PA/01398/23 (GF/00150/06): AMENDMENTS TO PA 1191/05 INCLUDING: INCREASE IN NUMBER OF APARTMENTS FROM 159 TO 234; RECONFIGURATION OF PARKING LEVELS TO INCREASE NUMBER OF PARKING SPACES FROM 600+ TO 850+; INTRODUCTION OF A GREEN PARKING AREA FOR ALTERNATIVE MODE OF TRANSPORT INCLUDING CYCLING, SCOOTERS, AND TAXIS; REMOVAL OF VEHICULAR ACCESS TO THE CAR PARK FROM HUGHES HALLET STREET LEVEL; INTRODUCTION OF HOTEL (CLASS 3B) TO ALSO SERVE APARTMENTS (CLASS 1); ADDITION OF AMENITIES LEVEL WITHIN DOUBLE HEIGHT LEVEL IN TOWER; CONVERSION OF RECESSED LEVEL OF TOWER HOUSING CORE INTO RECESSED LEVEL; REMOVAL OF THE PAVILION BUILDING; INTRODUCTION OF OFFICE LEVELS WITHIN DOUBLE HEIGHT AREAS IN LOWER BUILDINGS; INTERNAL RECONFIGURATION OF OFFICE SPACES; INTERNAL RECONFIGURATION AND SUBDIVISION OF RETAIL AND FOOD AND BEVERAGE OUTLETS, INCREASING THE TOTAL NUMBER OF CLASS 4B UNITS; CHANGING THE USE OF SOME CLASS 4C OUTLETS TO CLASS 4D AND INCREASING THE NUMBER OF CLASS 4D UNITS, INCLUSION OF EXTERNAL AREAS TO CATER FOR THE USE OF TABLES AND CHAIRS.

LOCATION: TOWNSQUARE, TOWER ROAD, HUGHES HALLET STREET, TIGNE STREET, QUI-SI-SANA LANE, IX-XATT TA' QUI-SI-SANA, SLIEMA.

4. COMMENTS RECEIVED BY ERA

Figure 4 – Plans of the proposed hotel (Source: EIA Coordinator Statement, August 2023, <https://era.org.mt/era-project/pa01191-05/>).

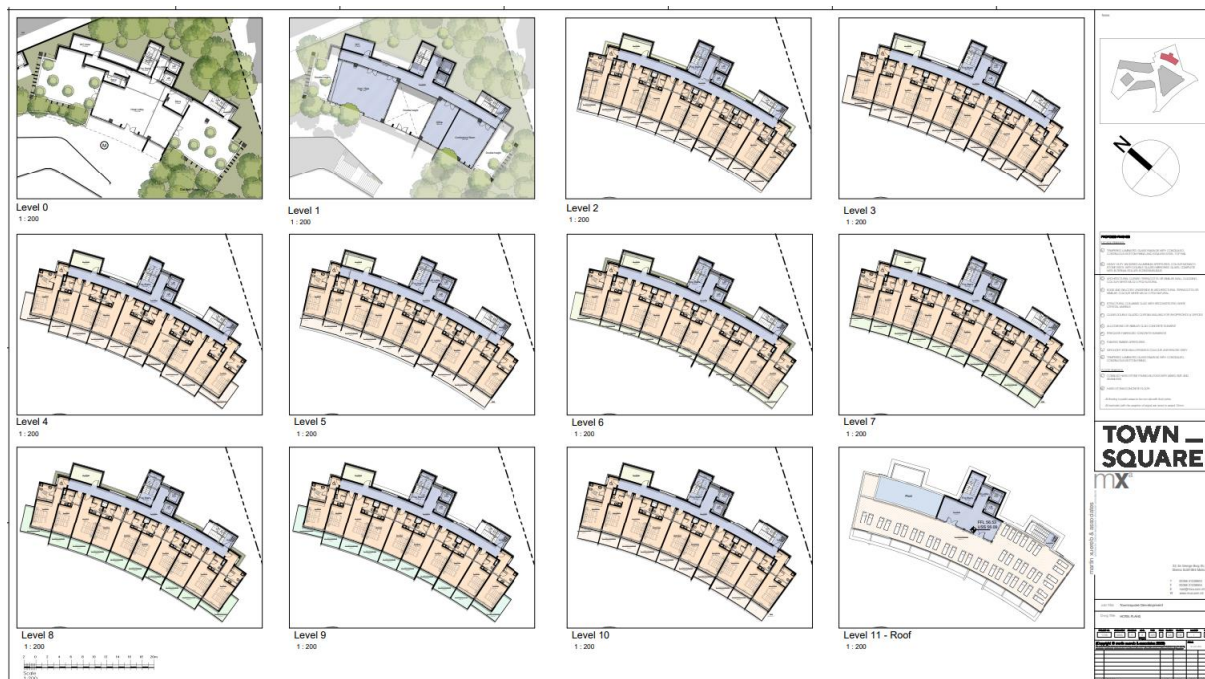
2	<p>The introduction of a hotel in an area previously reserved for an open space with no buildings close to Hughes Hallett street is an extreme revision from the original approved plan and an entire reassessment of the project must be held to ascertain the impact that this will have on environmental quality and logistical bottlenecks, and if so, the modification must be rejected.</p>	<p>Noted. The EIA Addendum considered the additional impact on air quality of the traffic generated from the hotel.</p>

Figure 8 – Area of study of the updated air quality study – indicating the selected sensitive receptors and main traffic routes (Source: Addendum to the EIA Report (Updated air quality study report, August 2023, <https://era.org.mt/era-project/pa01191-05/>).

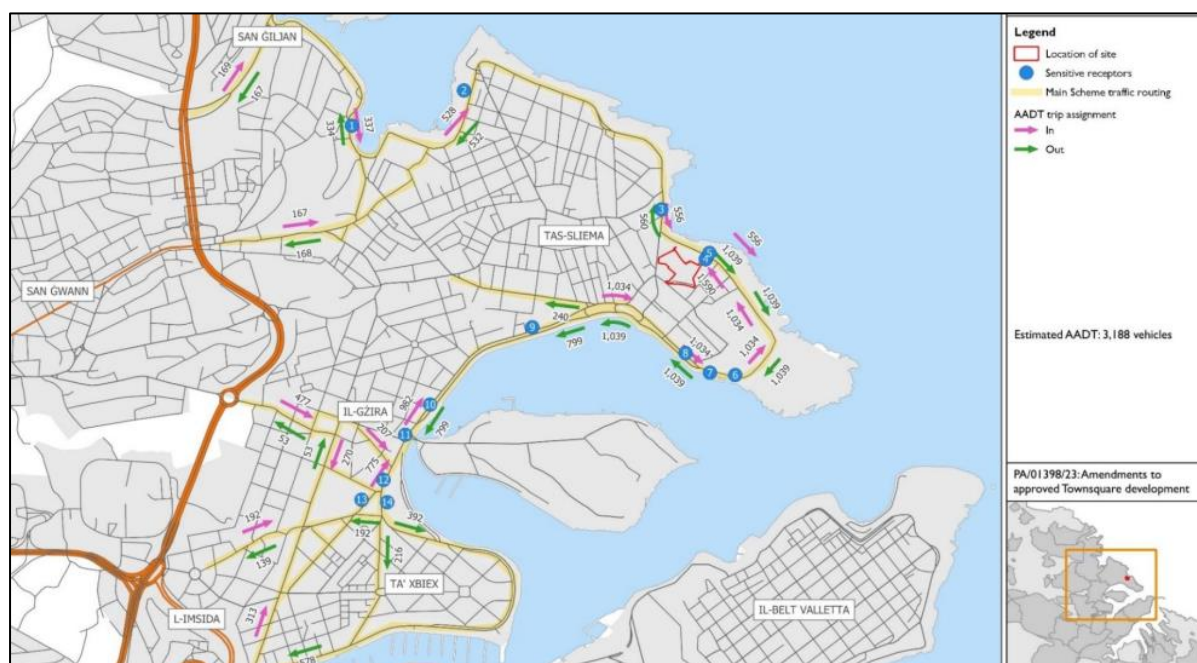
The study concludes that impacts from traffic in terms of NO₂ annual average concentrations are *not significant* at all sensitive receptors in both the year of commencement of operations (2028) as well as after five years (2033), and the allowable 18 exceedances of 200 µg/m³ as an hourly mean will be achieved.

With respect to PM₁₀, the study concludes that impacts on PM₁₀ annual average concentrations range from *not significant* to *moderate significant* (minor significant for receptor locations 4, 5 and 7 in both years, for receptor location 6 only after five years or operations, and moderate significant for receptor location 8), and the impact on the number of exceedances of the daily limit value range from *not significant* to *moderate significant* (moderate significant for receptor locations 4, 5, 6, 7 and 8 in both years, and for receptor location 9 only after five years or operations).

The study also concludes that the PM₁₀ daily limit values will be exceeded at all receptors considered, even without the development in place (i.e. baseline scenario), and the annual limit value will be exceeded at multiple sensitive receptors (1, 2, 4, 5, 8, 9, 10, 11, 12), even in the baseline scenario.

The implementation of a Green Transport Plan is proposed to mitigate adverse effects from increased emissions, and includes a number of measures and financial commitments aimed to shift the mode of travel of employees and visitors away from single occupancy passenger cars (e.g. promoting use of public transport, financial incentives for staff to use alternative modes of travel, shower and charging facilities for employees who walk or cycle, electric charging points for vehicles, collective private transport services for employees, flexi-time and working from home policies). The study assessed such measures as beneficial from an air quality perspective, although the consultants indicated that a reduction in impact significance is not envisaged.
